**Proposed final changes to Timaru mandatory  
broadcast zone  
– airspace user consultation**

Appendix A – proposed final MBZ and CFZ design

*Figure 1 – Rangitata South Irrigation Scheme ponds*

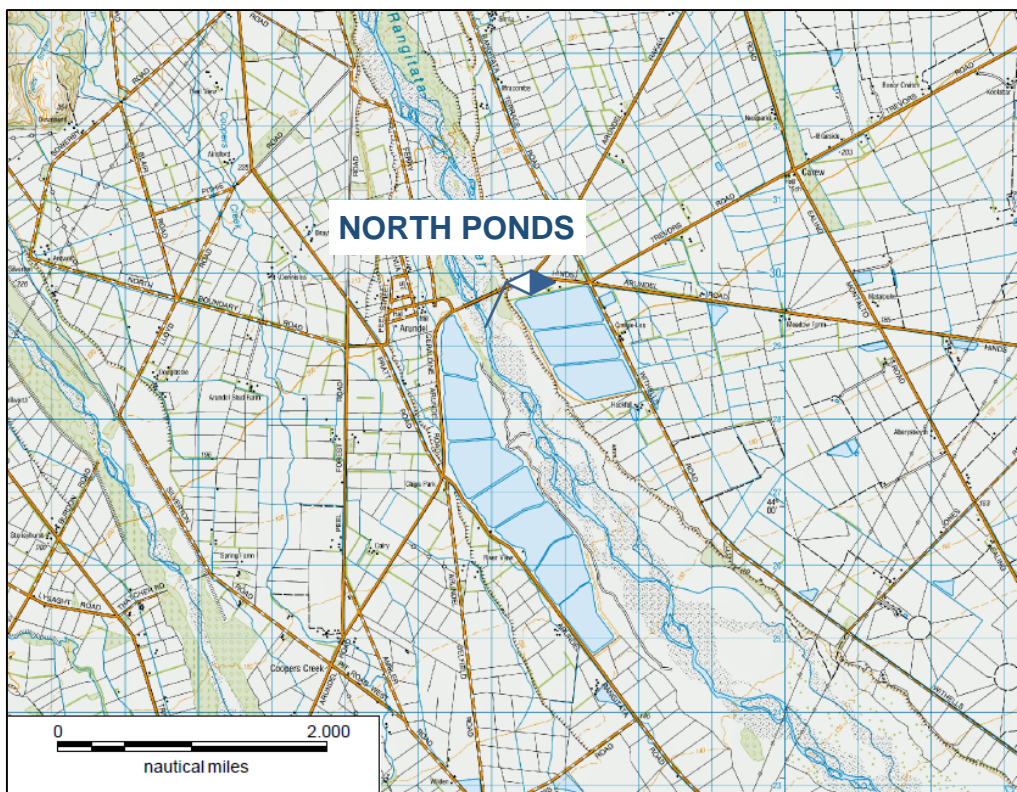
At the workshop a new visual reporting point was suggested for the Rangitata South irrigation scheme ponds, near Arundel. The ponds are not shown on the 2017 VNC and are a very prominent feature used by local pilots.

CAA understands that local pilots already report in relation to “the ponds”. However, there are five visual reporting points where variations using the word ‘pond(s)’ already designated in New Zealand. Therefore a new name is required.

At this stage, the name ‘NORTH PONDS’ is suggested for this location. Due to the size of the irrigation scheme, more than 2 NM in length, the coordinates for the VRP would be approximately S 43 58 56.7, E 171 18 23.9 at the position shown in Figure 1, between the northern ponds on both sides of the Rangitata River.

Figure 2 – ELDAK-IKALO track

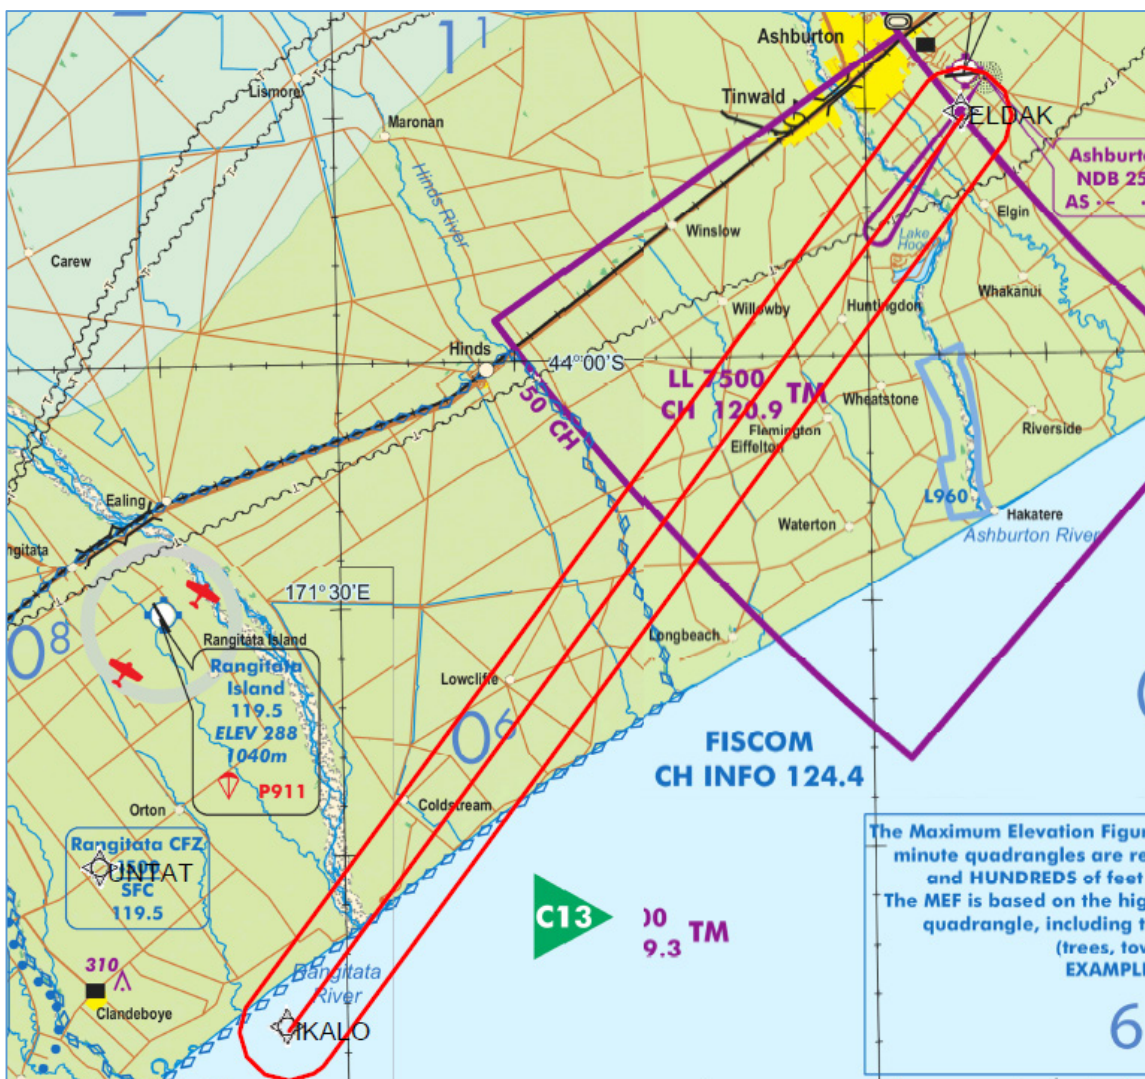
The western boundary of Timaru North and Timaru East is aligned further inland than was discussed at the workshop. This has been done to provide at least a 1 NM buffer from the centreline of the ELDAK-IKALO (and most likely new waypoint ZZZZZ). The buffer area is shown in red in Figure 2.
